Product Change Notification

Product Change #: PCN366

Parts Affected: Y6100-6005, Y6110-6005

Y6100 ID Callout Pre-Change

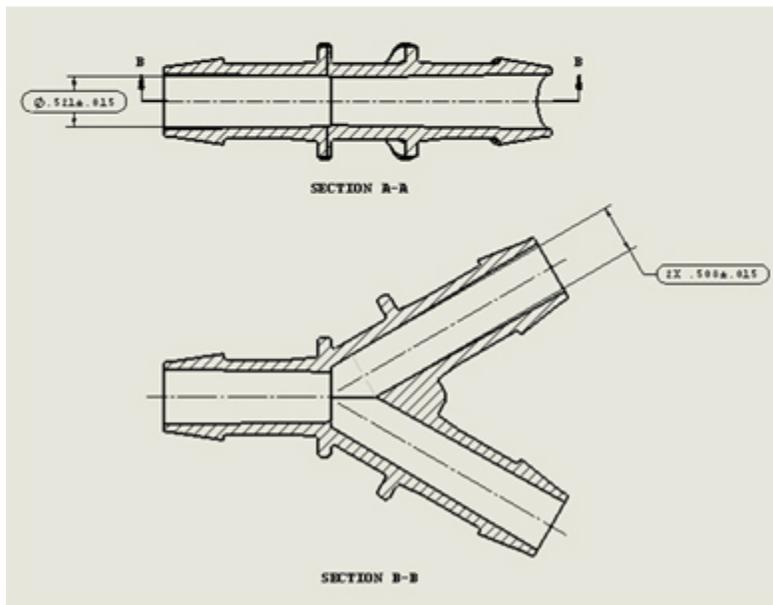
Description of Change: The ID snap will be called out differently to more closely represent how part is being inspected. Physical part will not change, only how the dimension is called out on the print.

Reason: Parts have been sent to MRB for the two leg's ID being above USL.
